M95128-DF package mechanical data modifications

This errata sheet applies to the M95128-DF, which is 128 Kbit serial SPI bus EEPROMs, and specifically to the device delivered in 8-bump wafer-level chip-scale packages (WLCSP).

The impacted part number is M95128-DFCS6TP/K.

Figure 2. D and E front side view

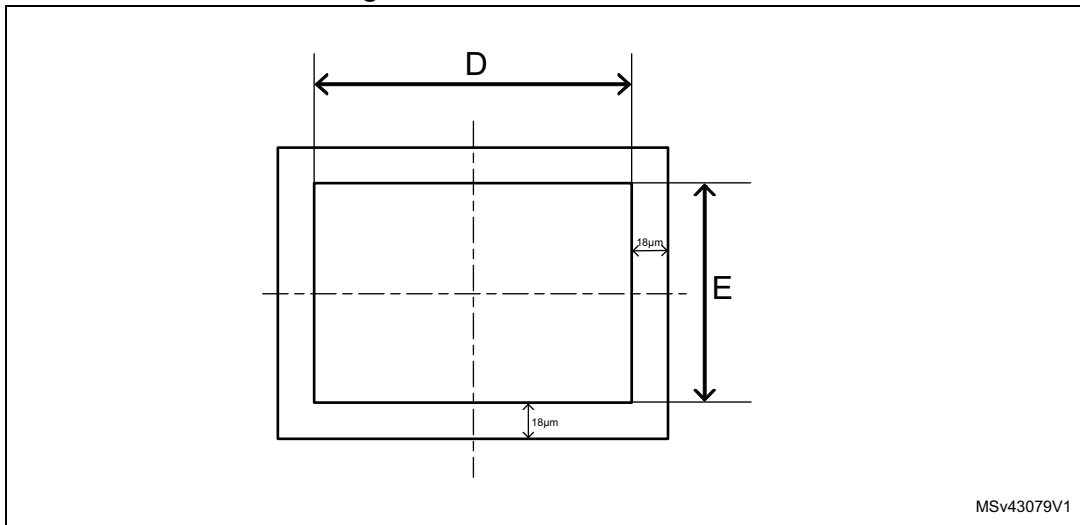
- The D and E values in the M95128-DF datasheet correspond to front side view (ball side), instead of back side view (marking side view).
[Table 1](#) and [Table 2](#) report the data for the front and back view, respectively.

Symbol	Millimeters			Inches		
	Min	Typ	Max	Min	Typ	Max
D	-	1.271	1.291	-	0.0500	0.0508
E	-	1.081	1.101	-	0.0425	0.0433

Figure 3. D and E back side view

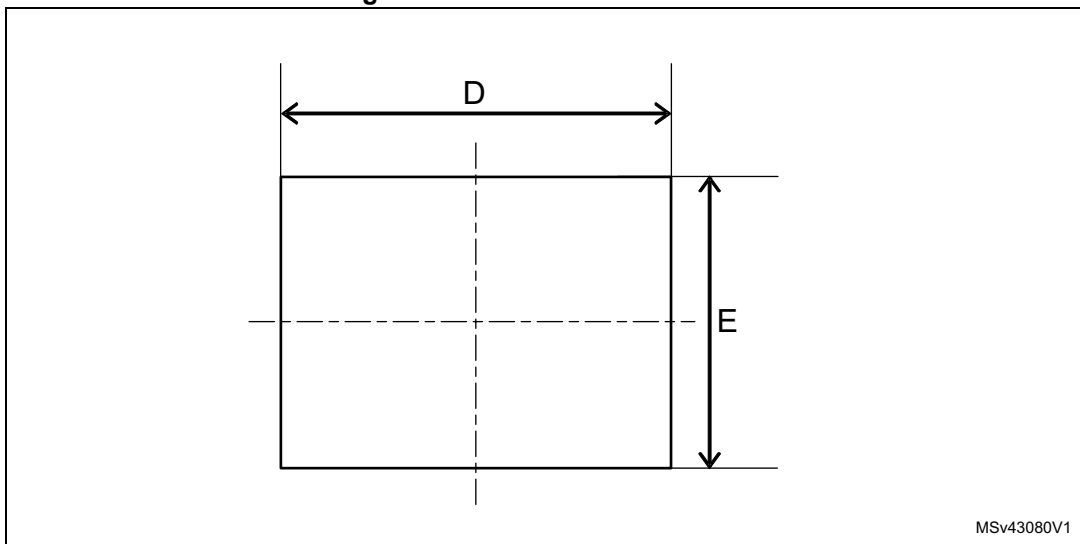
This document refers to the changes in dimensions D and E (see [Figure 3](#)) described in the M95128-DF datasheet, in tables detailing the dimensions of the WLCSP 8-bump package.

D and E values must be modified to correct the following mistake:

Symbol	Millimeters			Inches		
	Min	Typ	Max	Min	Typ	Max
D	-	1.289	1.309	-	0.0507	0.0515
E	-	1.099	1.119	-	0.0433	0.0441

Figure 4. D or E side view

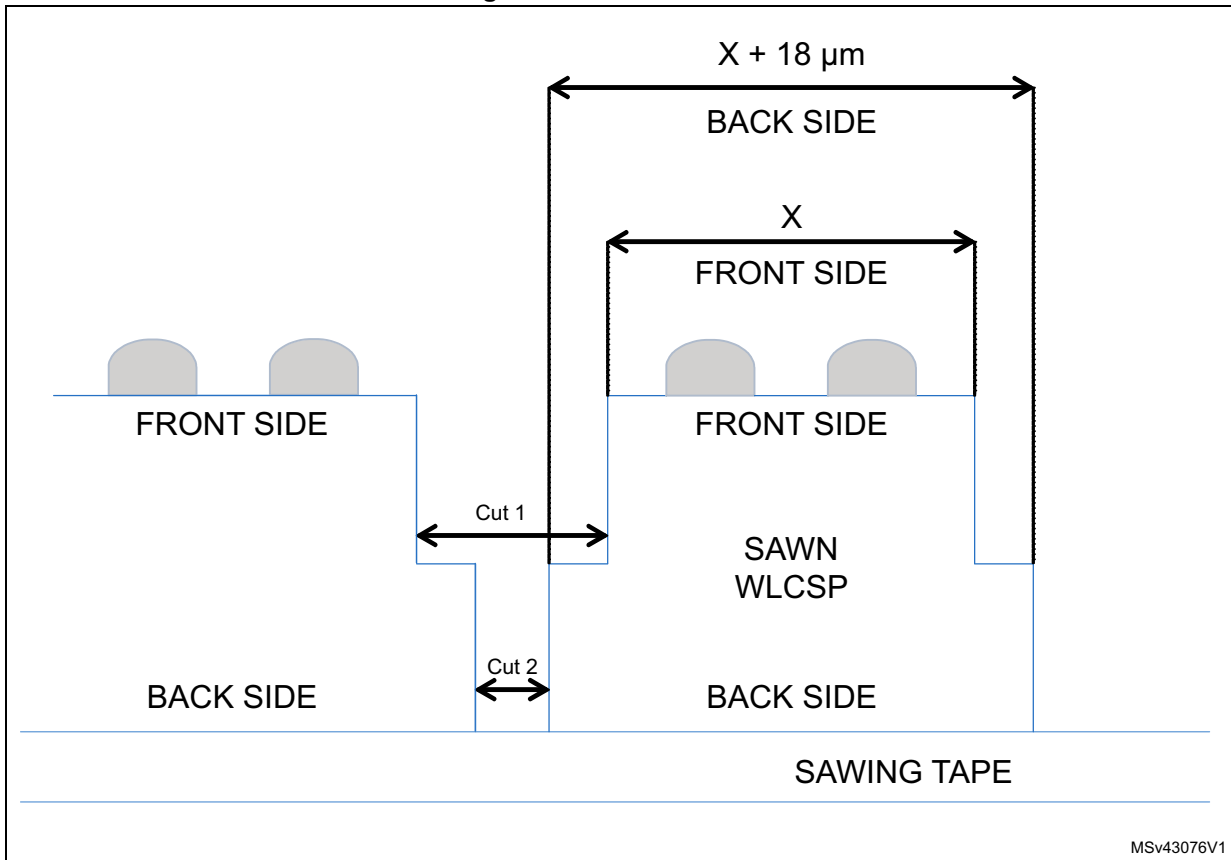
The difference between back side and front side dimension is 18 μm (0.018 mm). This difference is due to the two-step sawing process, where cut 1 and cut 2 are performed with blades having different thicknesses (see [Figure 4](#) in which X represents D or E and it has the same value and tolerance).
